From: The Columbia County Building & Zoning Department
Plan Review
135 NE Hernando Av.
P.O. Box 1529
Lake City Florida 32056-1529

Reference to a building permit application Number: **0710-01**

Pennyworth Homes Contractor, Owners: AAmir Perbtair Property ID# 01-5s-16-03401-111

On the date of October 2, 2007 application 0710-01 and plans for construction of a single family dwelling were reviewed. The following information or alteration to the plans will be required to continue processing this application. If you should have any question please contact the above address, or contact phone number (386) 758-1163 or fax any information to (386) 754-7088.

ELECTRICAL PLAN

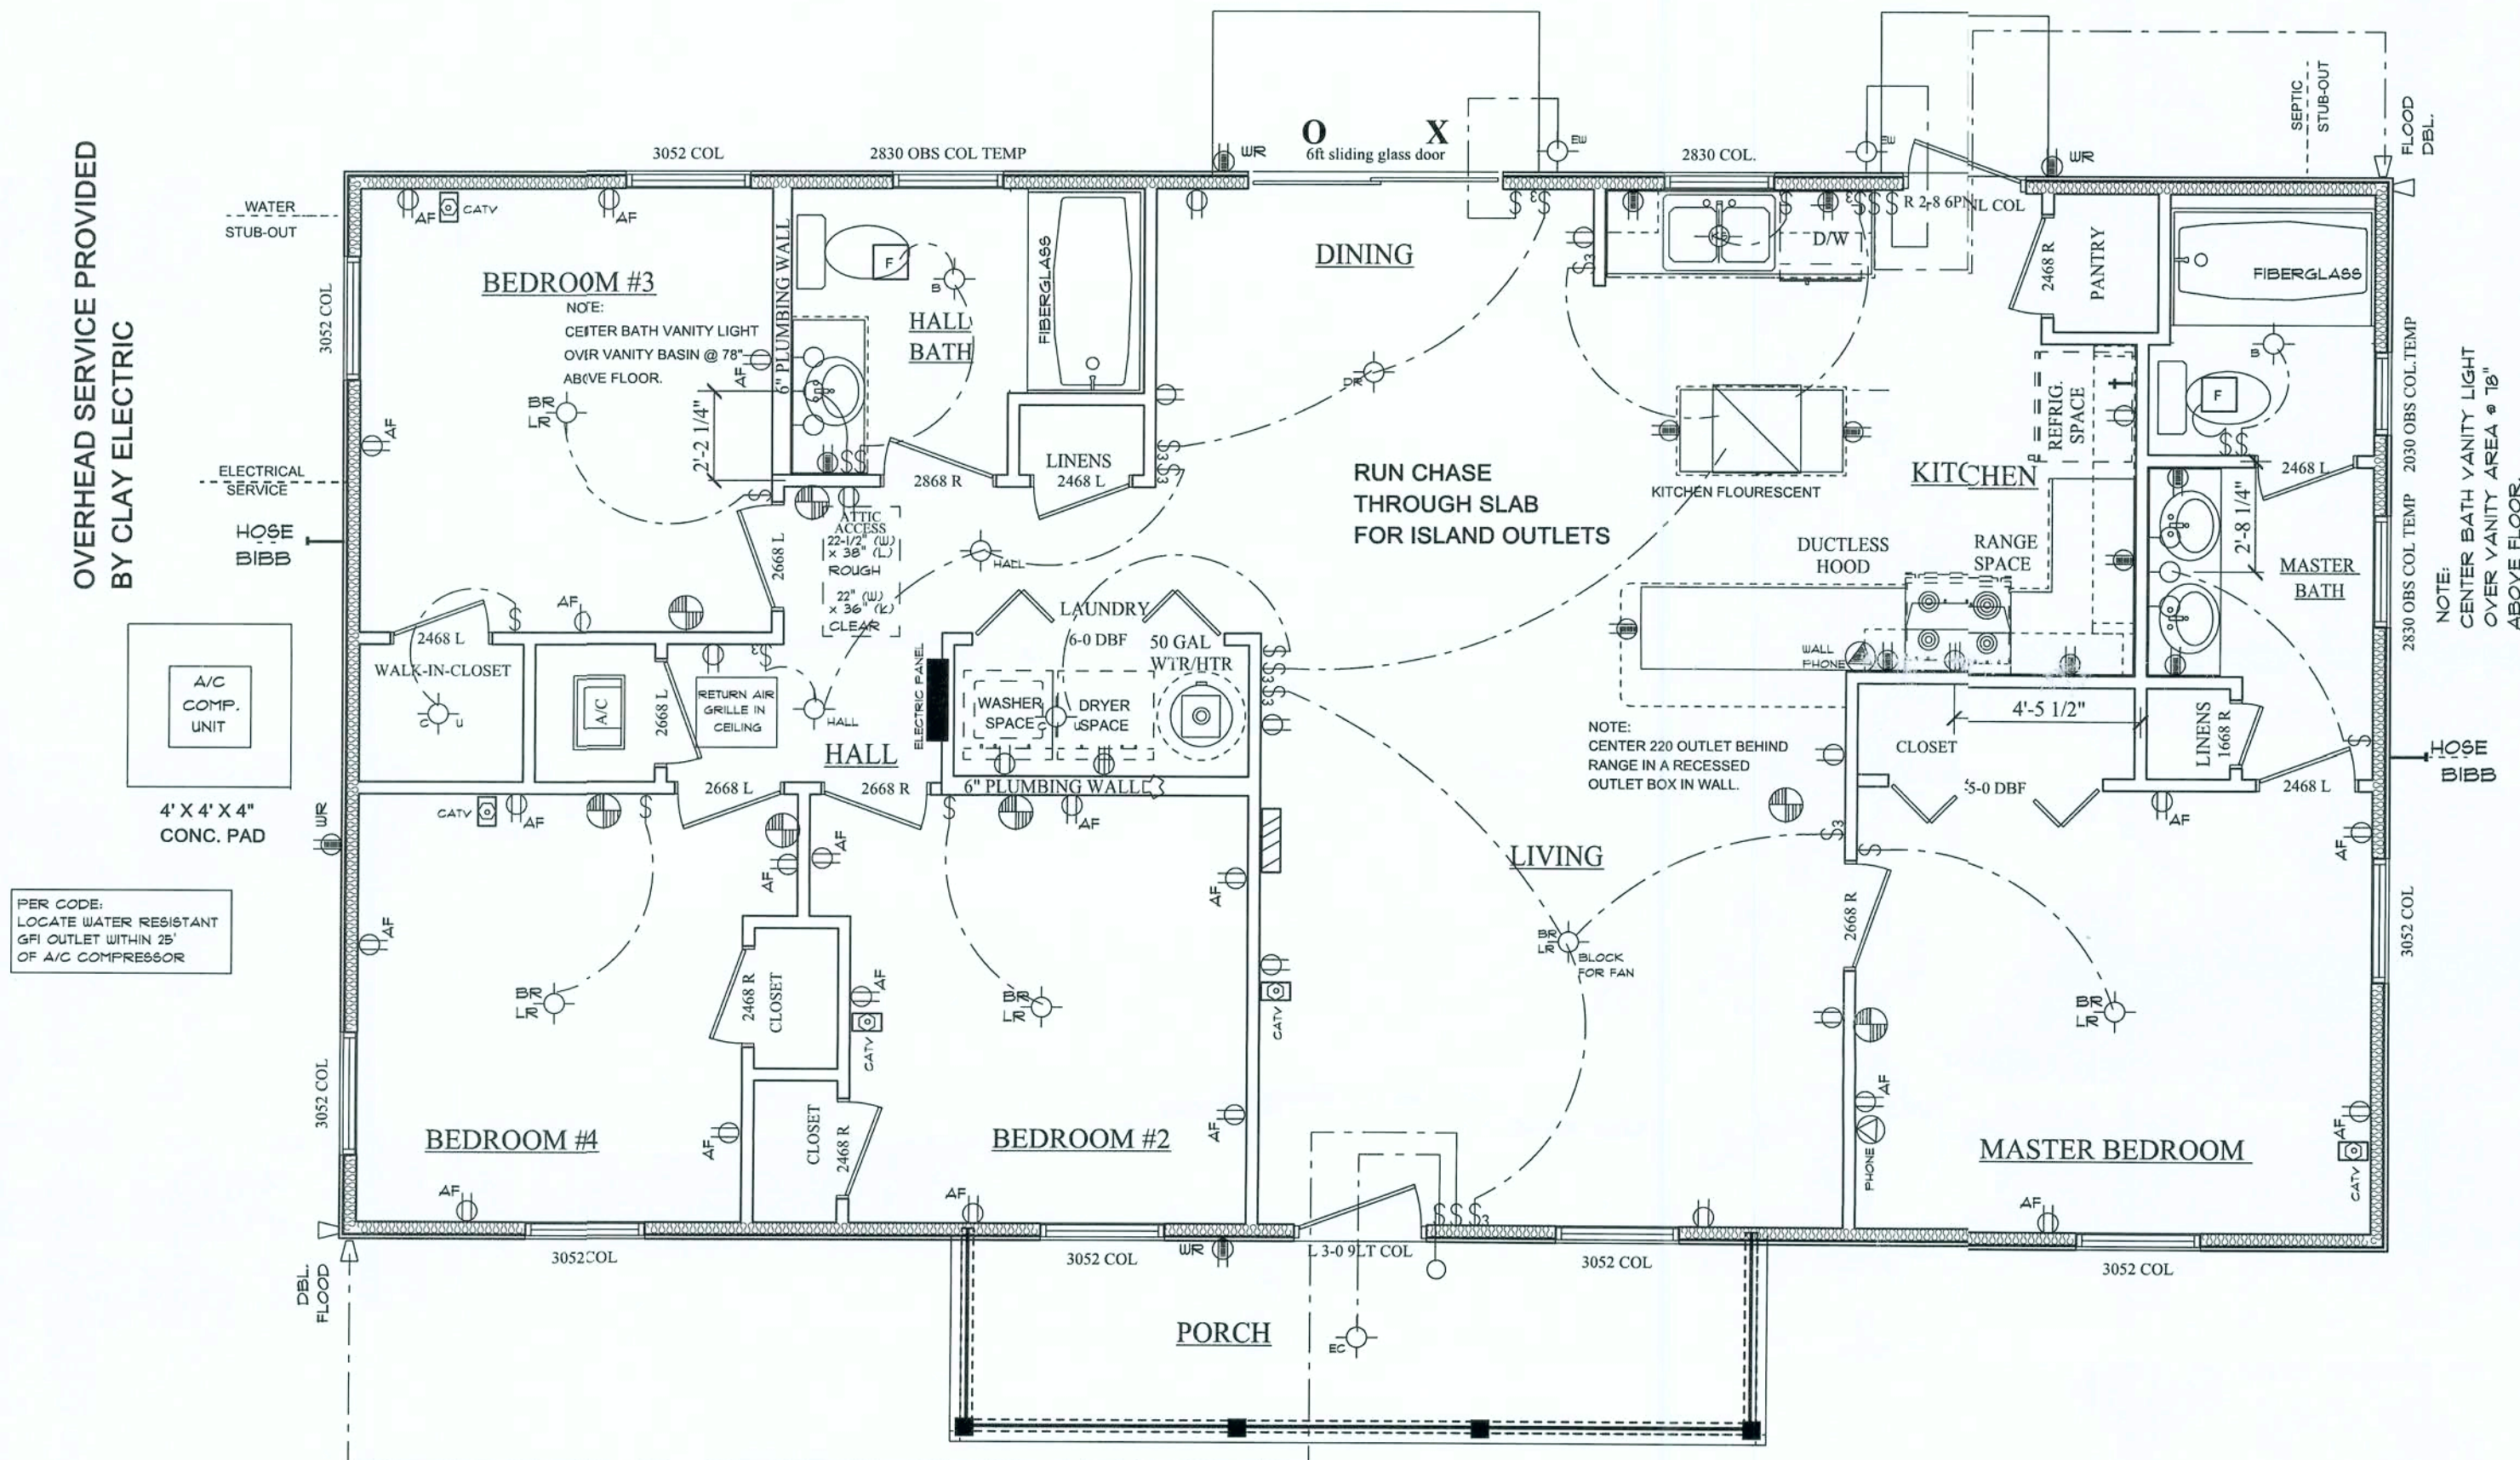
On the electrical plans identify the electrical service overcurrent protection device for the main electrical service. This device shall be installed on the exterior of structures to serve as a disconnecting means for the utility company electrical service. Conductors used from the exterior disconnecting means to a panel or sub panel shall have four-wire conductors, of which one conductor shall be used as an equipment ground.
